TECHNICAL SERVICE BULLETIN

October 16, 1968

Re: Hydraulic Knock from Oil Filter/Oil Cooler

MGC

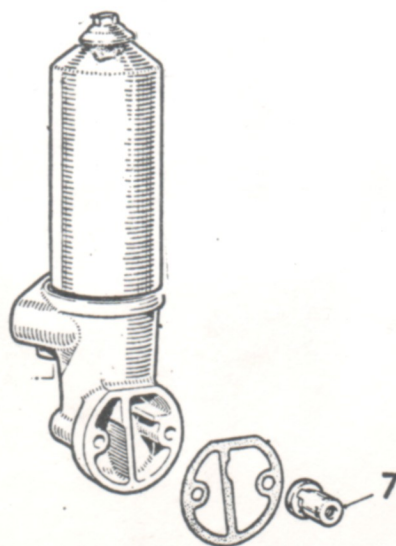
Commencing at (approximate) Engine No. 29GA/357 seat 'A' in the oil pressure release valve 13H 4214 was reversed, i.e., with the chamfer 'B' of the seat facing the valve 'C'.

On engines prior to the above change point, this modification can be carried out by removing the filter assembly complete from the block - remove the gasket, and with two thin screwdrivers ease out the release valve Item "7".

Drift out the Valve "C" and Seat "A". Reverse the seat and re-peen.

It is recommended prior to fitting a valve 13H 4214 from your stock, you verify which way the seat is installed and reverse it if necessary.
